This letter is with regards to 3 building permits (#359225, #359231, #359232) issued by your department on 01/10/2014 to Highland Restoration Group LLC (from here on, HRG) related to the construction of a new building on the lot located at 1505 Rosewood Ave.

## Supporting Documentation – Supplement to Letter to Dr. Jim Mims

### 1 – Failure to meet requirement set forth by the Private Yard Area variance granted by BOZA in 2005

Figure 1 (Based on excerpt of 2013 building permit application document C3 - Site Layout Plan)

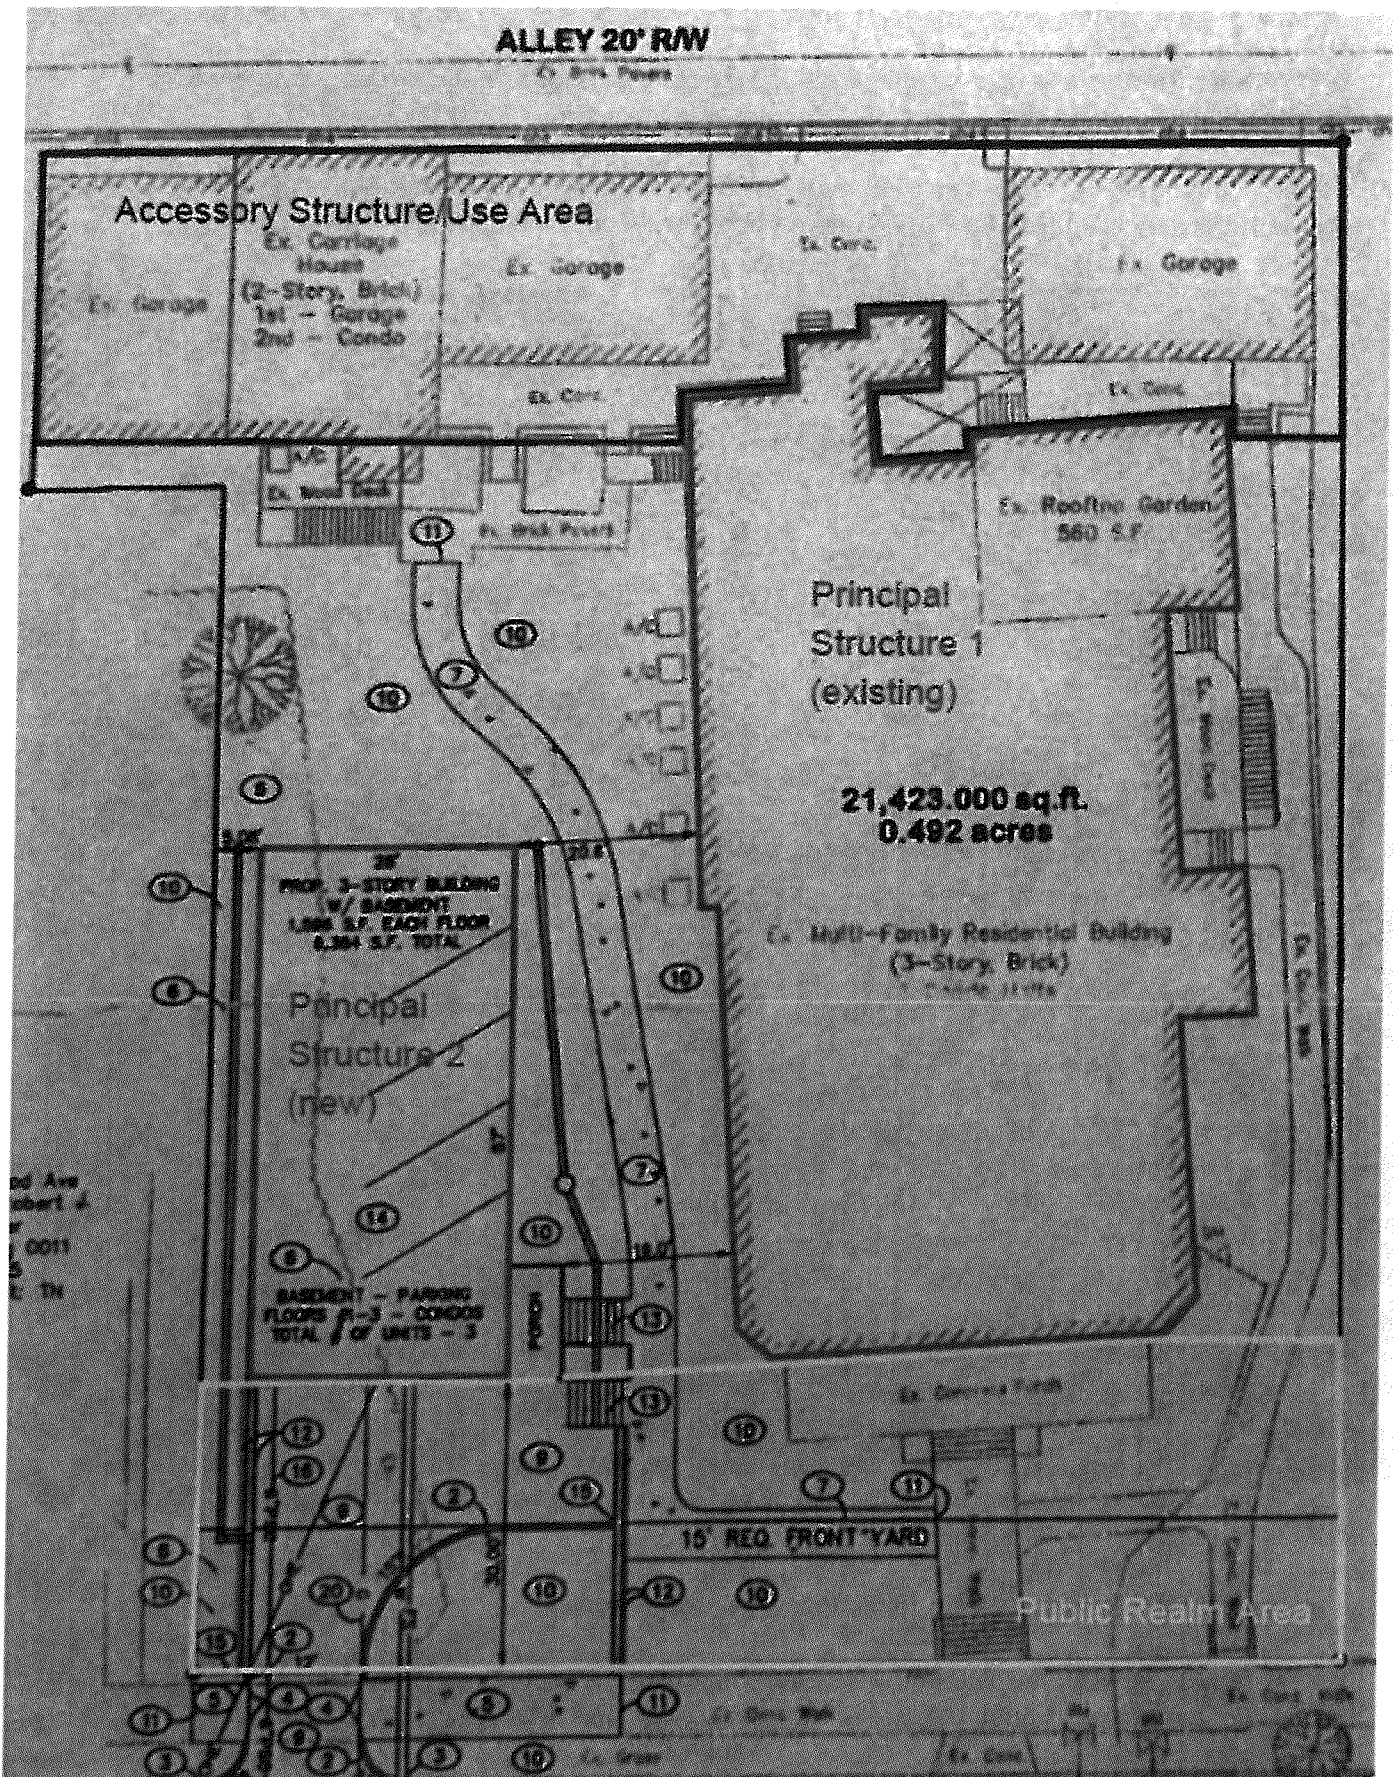
The first observation is that no area on this site fits the strict definition for Private Yard Area since the Principal Structure Area and the Accessory Structure/Use Area share a common boundary.

Figure 2 (Based on excerpt of 2013 building permit application document C3 – Site Layout Plan)

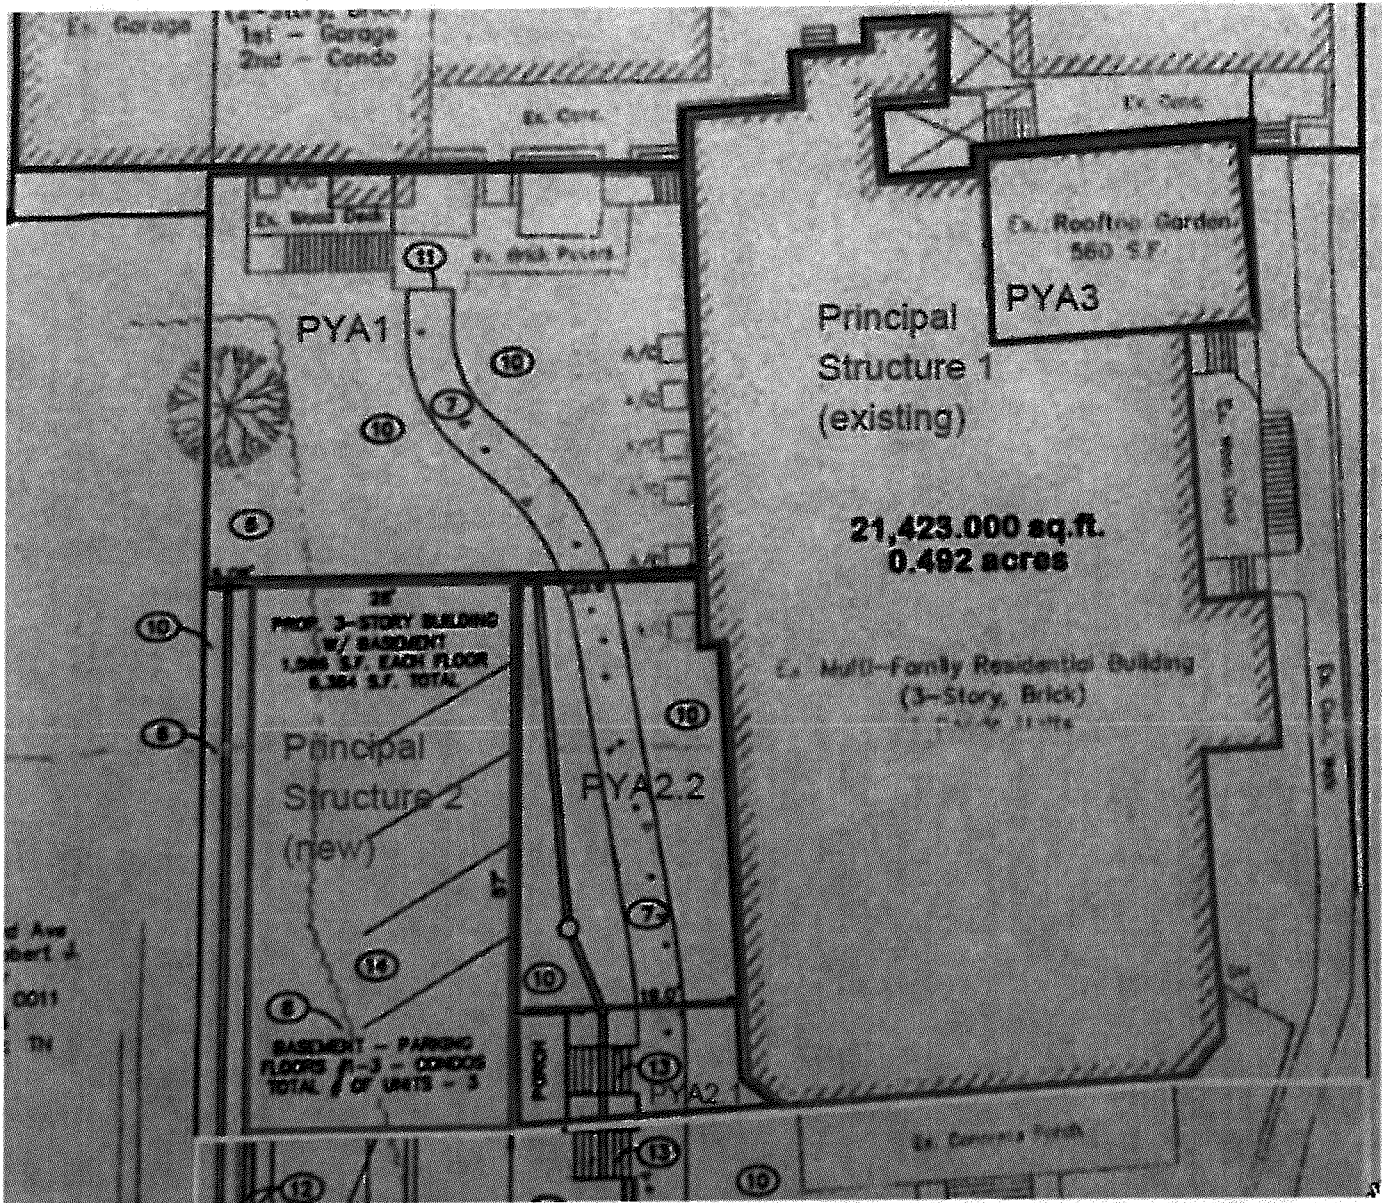
- PYA1: between the back of the new building, the left side of the existing building and the front of the Accessory Structure/Use Area. This surface is technically an encroachment in the Principal Structure Area.

- PYA2.1: between the first twelve feet of right side of the new building (measured from the front façade), and the corresponding section of left side of the existing building. This surface is also an encroachment in the Principal Structure Area, and it does not meet the minimum dimension requirement of “20 feet for a lot of 6,000 sf. or more” found in LDC 2006 – 5.4.1.D.2 (p. 524) for the following reasons:

- the covered porch cannot be counted as Private Yard Area (LDC 2006 – 5.4.1.D.1)
  - there are only 19 feet between the left most side of the porch and the right side of the existing building (and significantly less than 19 feet from the edge of the porch stairs)

- PYA2.2: the remainder of the area between the left side of the new building and the right side of the existing building. This surface is also an encroachment in the Principal Structure Area.

- PYA3: the so-called ‘Rooftop Garden’, is actually a plain wooden deck, built on top of the existing building roof, and is clearly disqualified by LDC 2006 – 5.4.1.D.1 (p. 524) which states:

It is clear from these observations, that even a very liberal interpretation of the code leaves the developer with at most the ability to claim PYA1 and PAY2.2 as Private Yard Area. Assuming generous measurements of the dimensions involved, these surfaces represent respectively:

- PYA1: 45 ft by 52<sup>4</sup> ft = 2,340 sf
- PYA2.1: 45 ft by 23<sup>5</sup> ft = 1,035 sf

For a total of **3,375 sf**, a value that is not even close to meeting the requirements set by the Private Yard Area variance<sup>6</sup> that was granted in 2005 for the entire development project by BOZA.

**Appendix A – 6 HVAC units inside the proposed Private Yard Area**

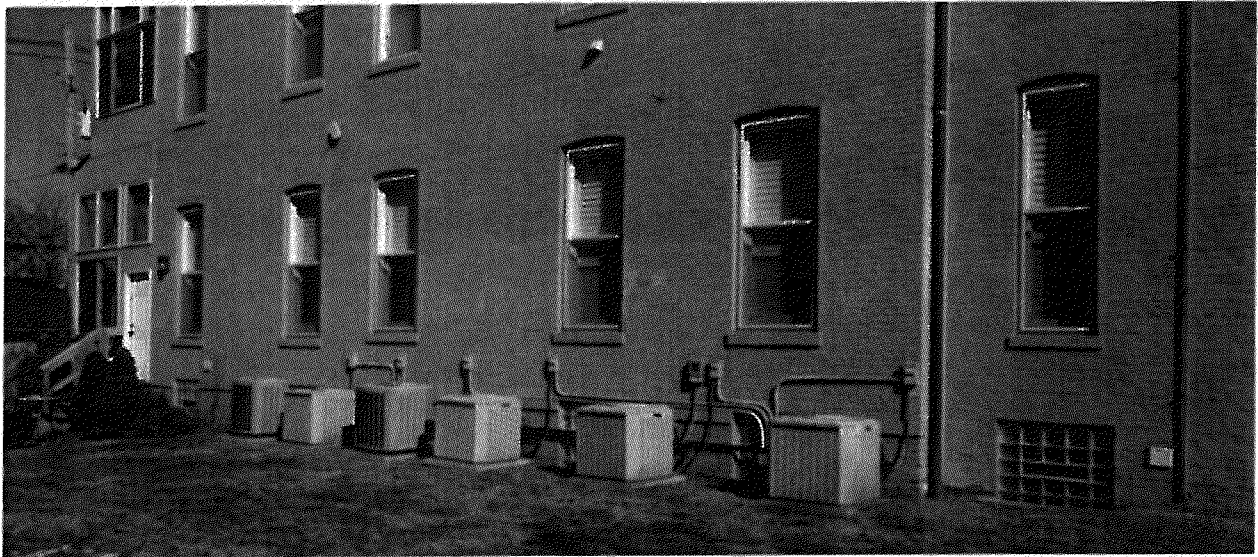
Note also that there are encroachments both in PYA1 and PYA2.1, in the form of 6 A/C units, covering approximately 32’6” by 4’6”, further reducing by approximately 146 sf the area that is really usable as a private yard (see Appendix A).
